# Requirement notice

RPI22/002 Ensham – Life of Mine Extension Zones 2 and 3 (Given under s44 of the Regional Planning Interests Act 2014 (RPI Act))

Project Ensham – Life of Mine Extension Zones 2 and 3

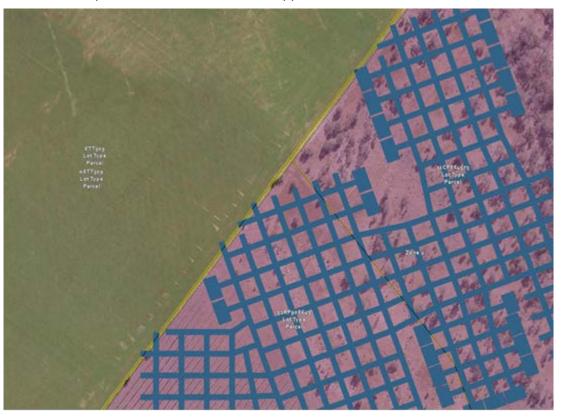
Section 4.8 in Appendix E (Subsidence Management Plan) of the supporting document details mitigation measures that may be required if a significant detection of subsidence occurs. There is insufficient information to consider if these measures are appropriate.

Confirm what significant detection means and provide mitigation strategies and measures that detail actions and compensation (if required) to ensure there is no agricultural loss in affected areas, in terms of capacity, productivity and area used.
